LINDSTRAND BALLOONS LTD

SERVICE BULLETIN No 6

ISSUE 1 – DATED 24-8-99

Title: BURNER VALVE REPAIR

FIG 2. JETSTREAM SERIES 2 BURNER SQUEEZE ACTION MODE

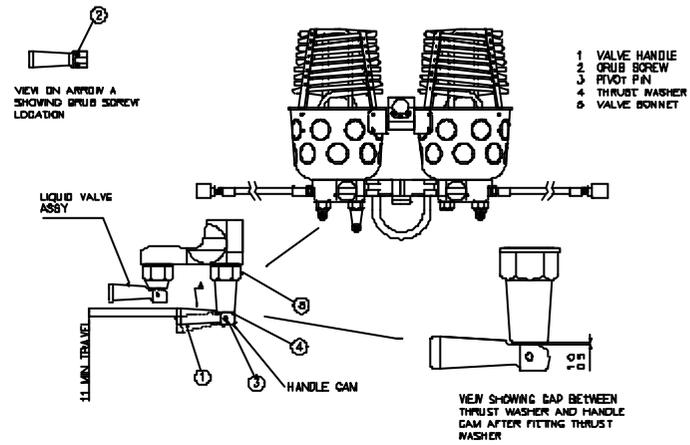
- 3 If the valve handle travel is less than the minimum specified on figures 1 and 2, then the plastic thrust washer (items 4 and 13, figs 1 and 2 respectively) must be replaced as described in the Recovery Action section below.

- 10 Select the new thrust washer from the two supplied to give a clearance between the valve handle cam and the plastic thrust washer of between 0.5mm and 1mm (see figure 2). Note the thrust washer thicknesses as follows:

Thrust washer type BU-008-A-050-A	2.5mm thick
Thrust washer type BU-008-A-050-F	2.0mm thick
- 11 Align the holes in the handle cam with the hole in the valve spindle and replace the pivot pin.
- 12 Fit a new circlip to the pivot pin using a pair of external circlip pliers.
- 13 Using a set of feeler gauges, check that the clearance between the valve handle cam and the thrust washer is between 0.5mm and 1mm as shown on figure 2.
- 14 Place the lower and upper valve posts in position and fit the handle tube.
